**TO:** *All Bidders*  
**FROM:** *Katy Radder, Project Manager*  
**DATE:** *November 14, 2013*  
**SUBJECT:** *Main Street Tree Installation Project – ADDENDUM 1*

**ADDENDUM NO. 1**  
**To the Contract Provisions for**  
**City of Ferndale, Washington**

**MAIN STREET TREE INSTALLATION, DOUGLAS TO CHURCH ROADS,**  
**FERNDALE**  
**Small Works Project No. ST2013-04**

# TREE PLANTING DETAIL

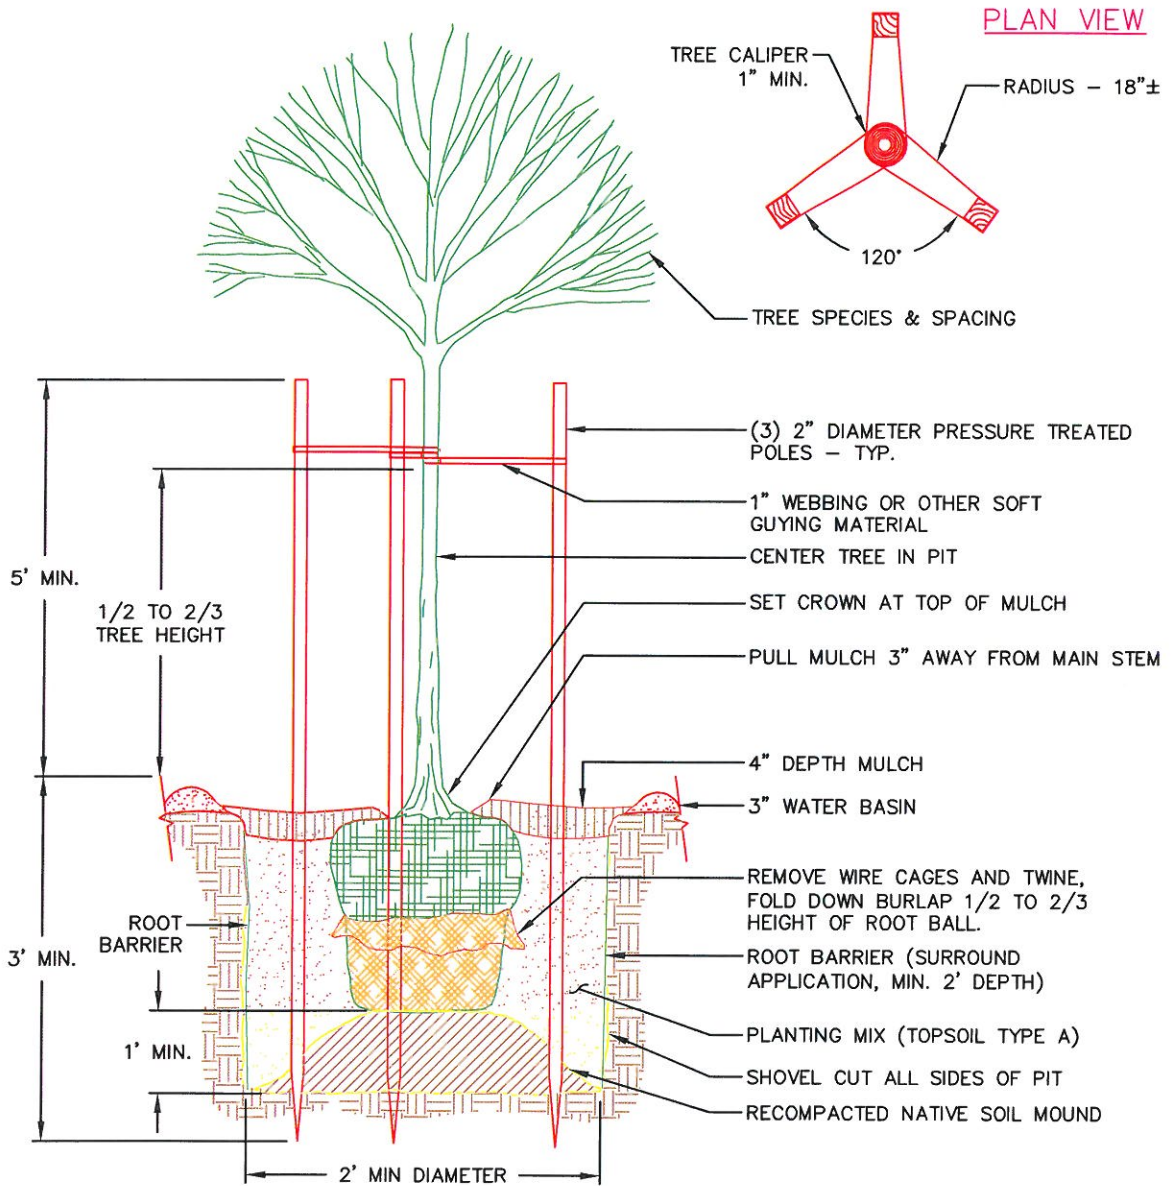
The attached Tree Planting Detail shall replace the Tree Planting Detail distributed as part of the Contract Documents. It has been revised to show a minimum 1" tree caliper, a root barrier depth of 2', and a pole length of 8'.
